In Reply Refer To:
HSST-1/B-265 REVISED

- Modified Three-Tube Bridge Rail (BR208)

Request for Federal Aid Reimbursement Eligibility of Highway Safety Hardware using Finite Element Analysis (FEA)

TITLE OF PROJECT BARRIER CRASH TEST SIMULATION	CONTRACT NUMBER:
LOCATION OF PROJECT	DATE: 04/19/2016
TITLE OF DRAWING UNIT 11 - SUPERSTRUCTURE BRIDGE BARRIERS OUTLINE & REINFORCEMENT 2	DRAWING NUMBER:

PEDESTRIAN FENCE AND CONDUITS NOT SHOWN FOR CLARITY

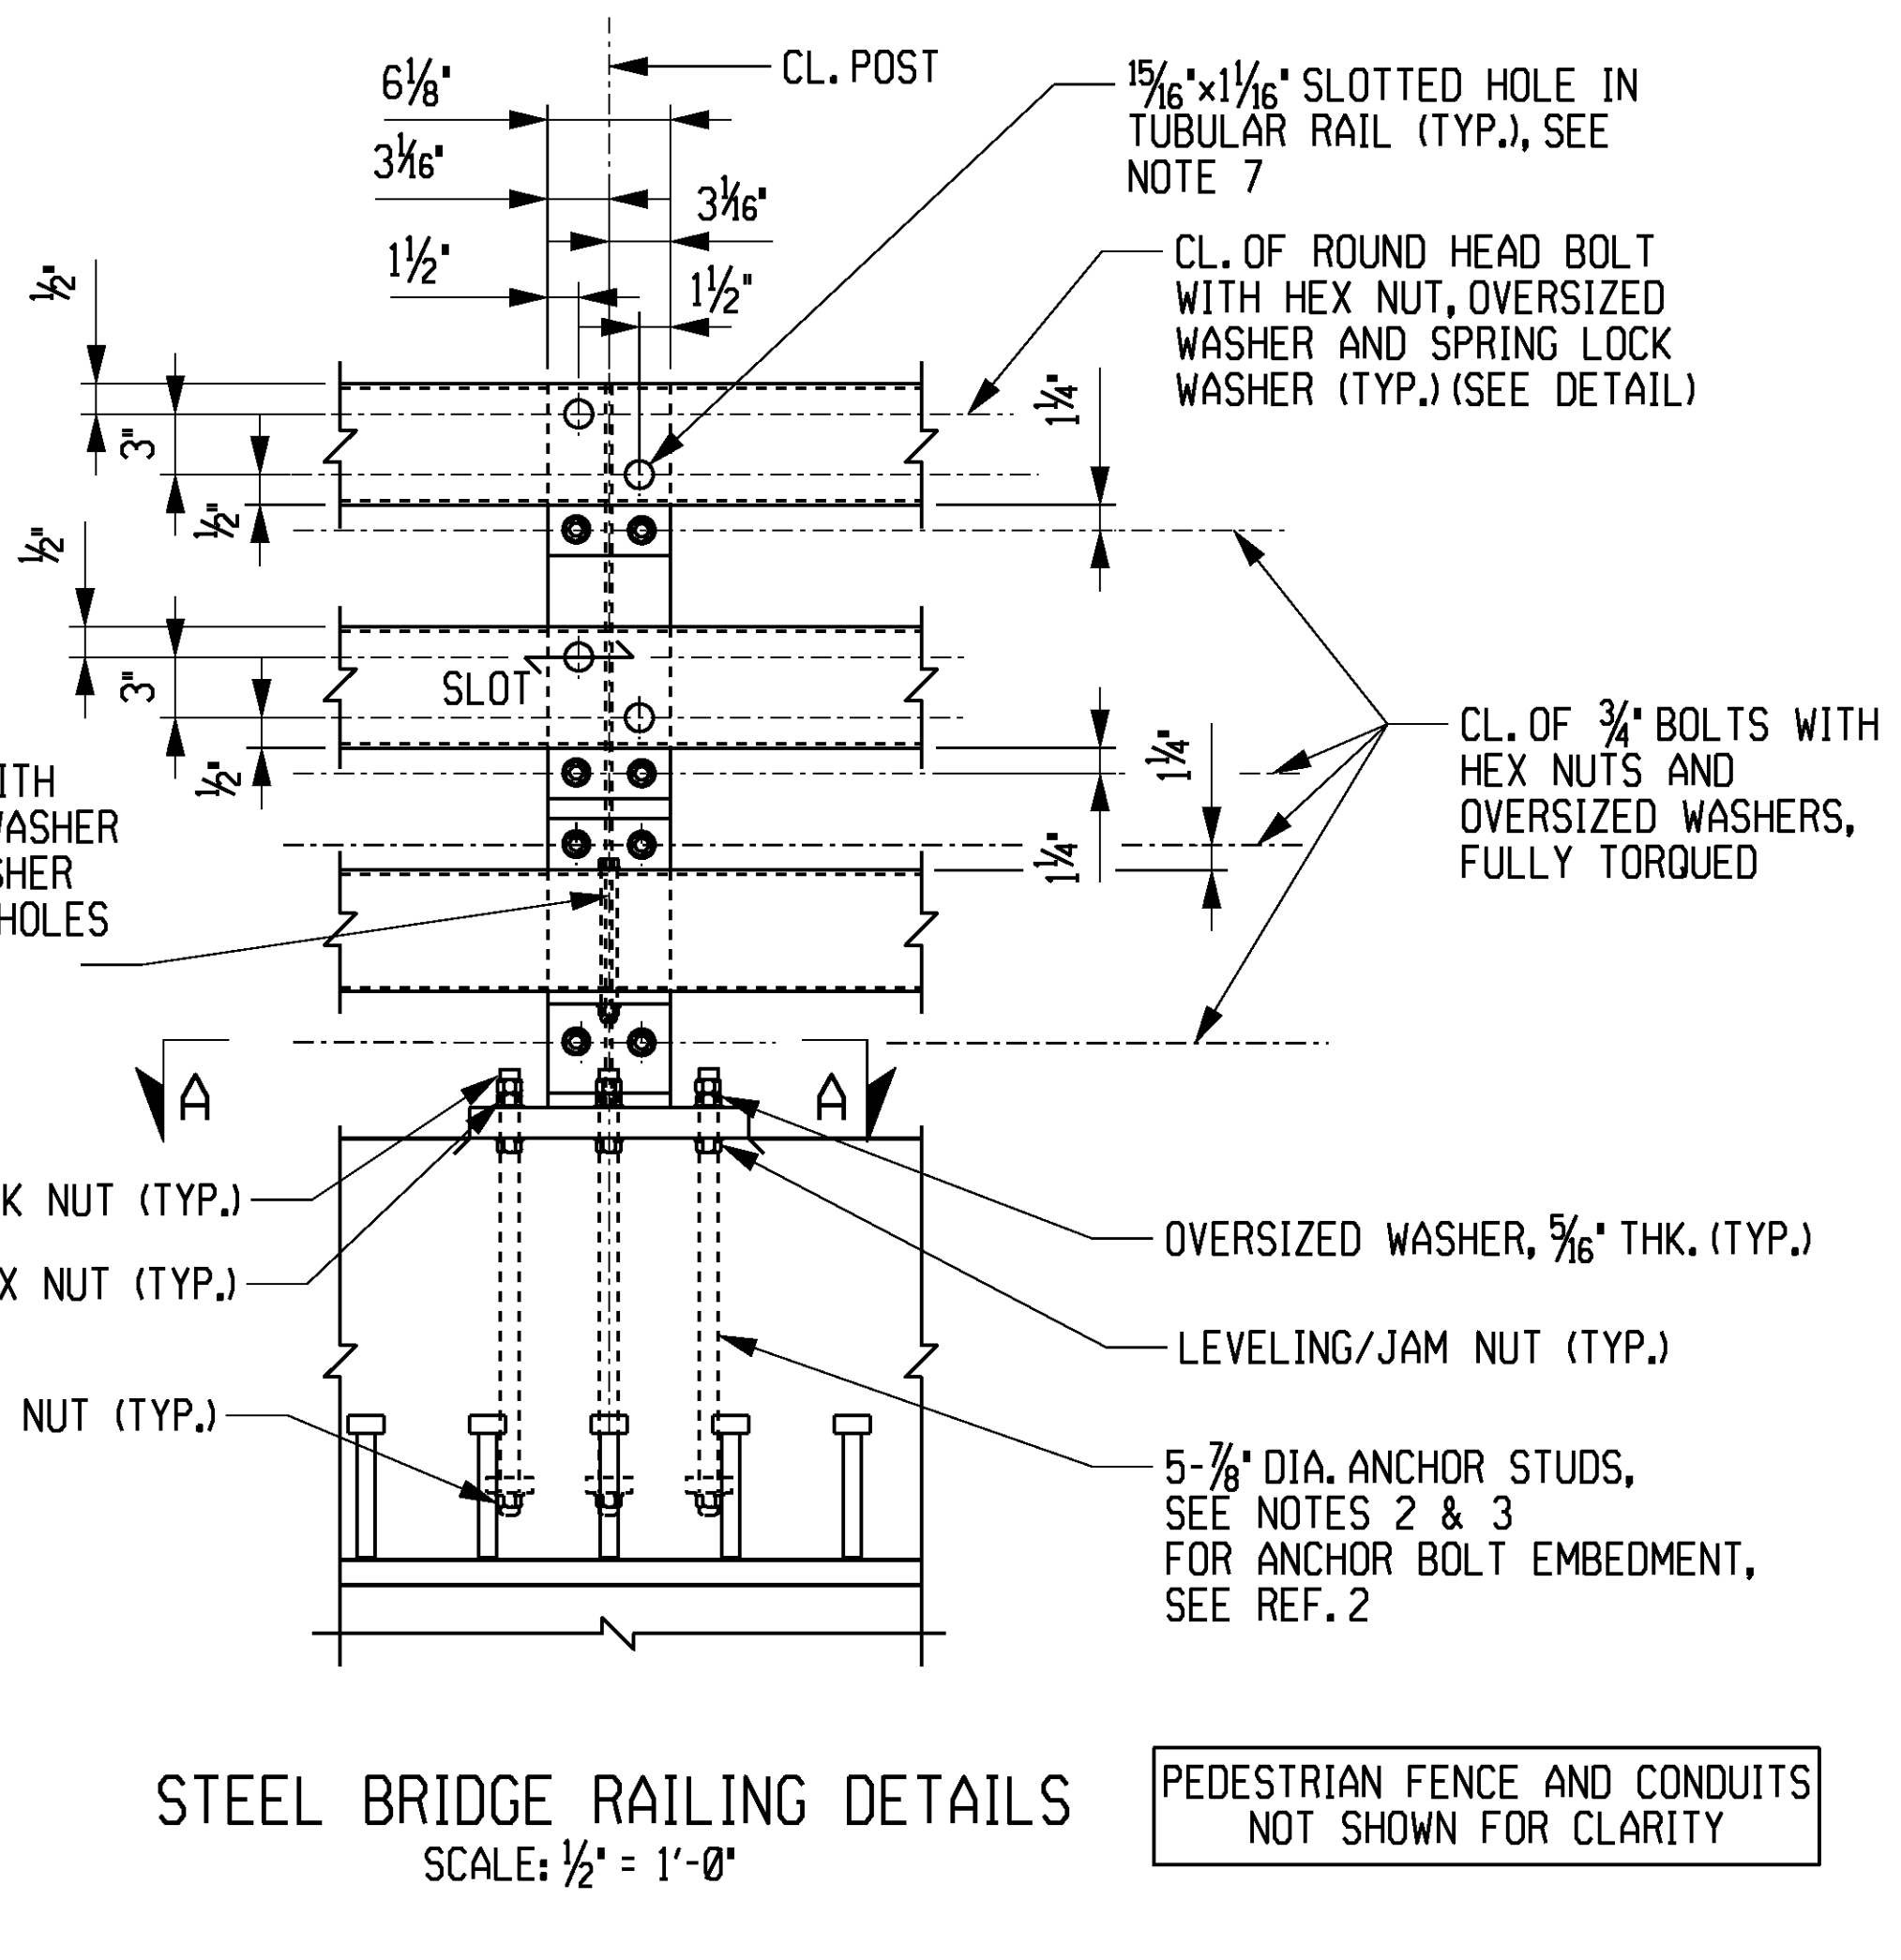
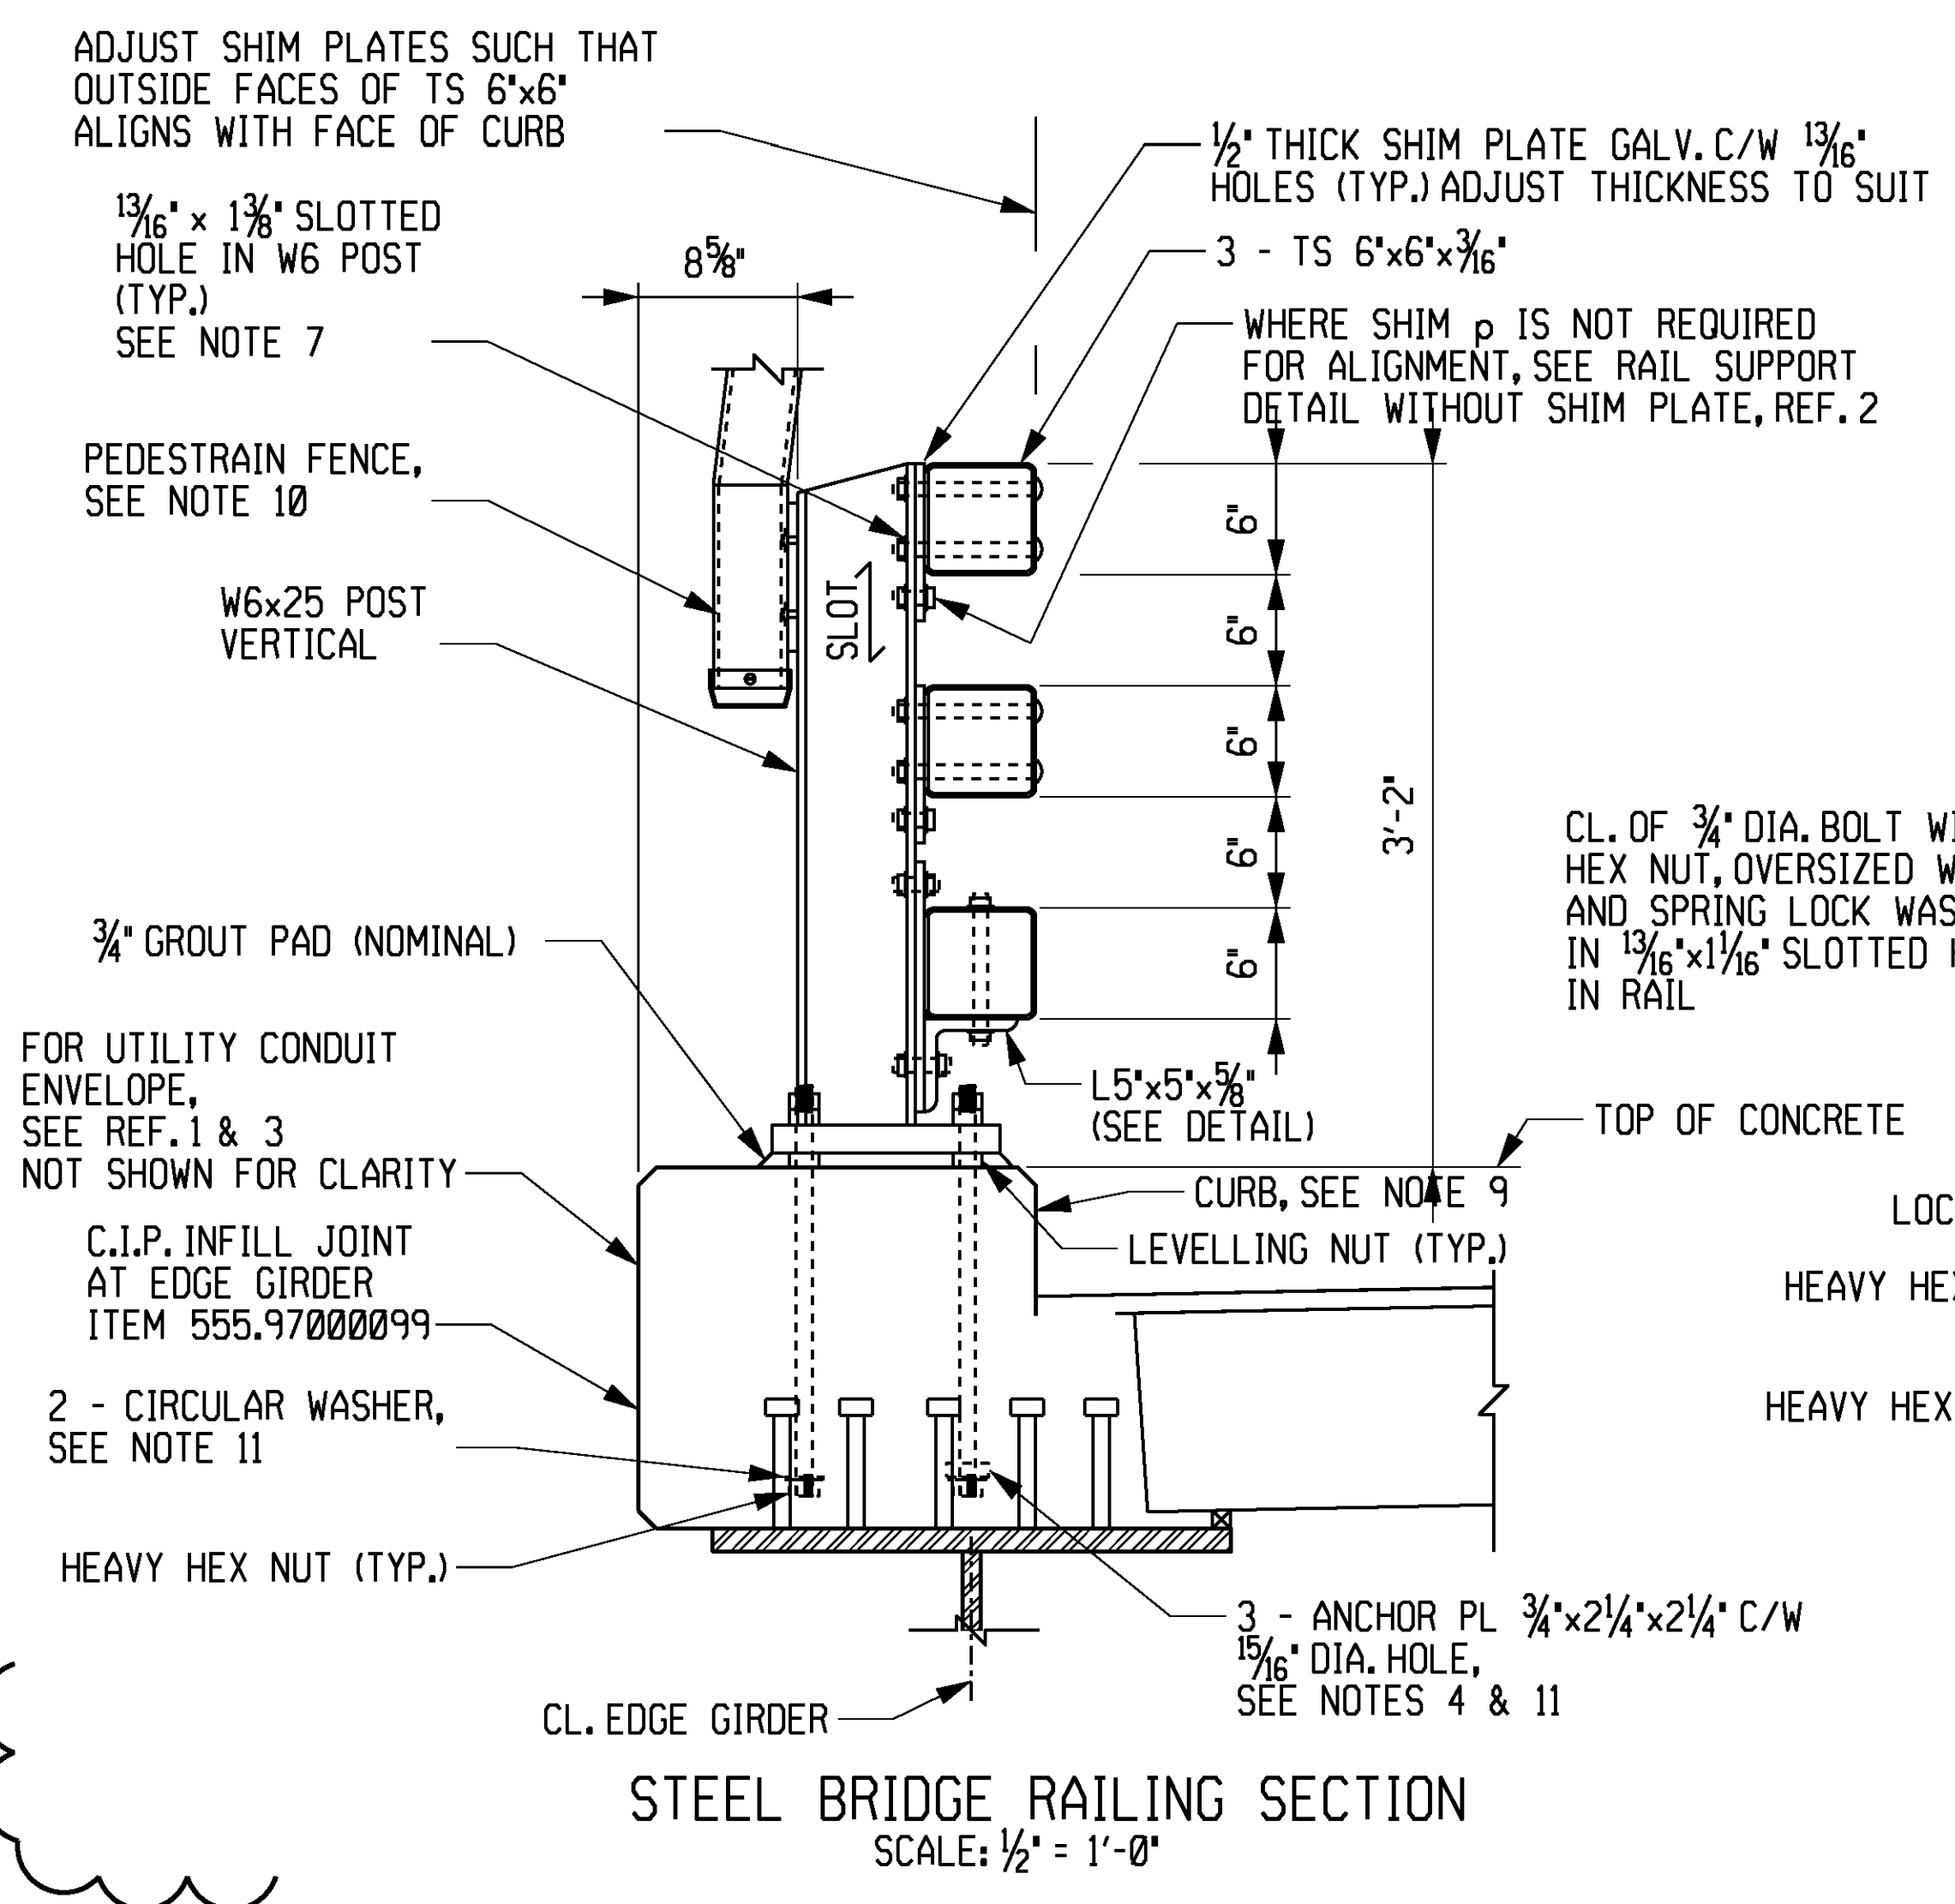
1. Changing the post type from a W8x24 to W6x25.
2. Decreasing the post spacing from 9.84 feet on center to 4 feet on center.
3. Increasing the overall top-of-rail height from 42 inches to 45 inches.

4. Eliminating the block out sections for lower rails and changing the rail sections to TS 6 x 6 x 3/16 inch for all three rails. The design also includes a 1/2-inch thick shim plate between the post and rails, which was not included in the model. With the shim plate the resulting distance from the traffic face of the rails to the front flange of the posts is 6.5 inches, which is 1/2 inch less than the BR208.

5. Replacing the 3/4-inch diameter stud bolts that fasten the rails to the posts in the original system with 3/4-inch diameter round-head bolts for the top and middle rails. The lower rail in the modified design is supported on an L5 x 5 x 5/8 inch angle section with a single 3/4-inch diameter bolt passing vertically through the tube and angle support bracket. The support is fastened to the post using two 3/4-inch bolts with nuts and washers.

6. Increasing the number of mounting bolts used to fasten the bridge rail to the top of the curb from 4 bolts to 5 bolts. The additional bolt is placed on the traffic side of the mount-plate (tensile side) in-line and at the midpoint of the other two mounting bolts.

7. Increasing the embedment depth for the anchor bolts from 14 inches to 16.75 inches.
8. Increasing the curb width by 3/4-inch (i.e., increasing from 19.5 inches to 20.25 inches).

FHWA concurs with the recommendation of the accredited crash testing laboratory as stated within the attached form.
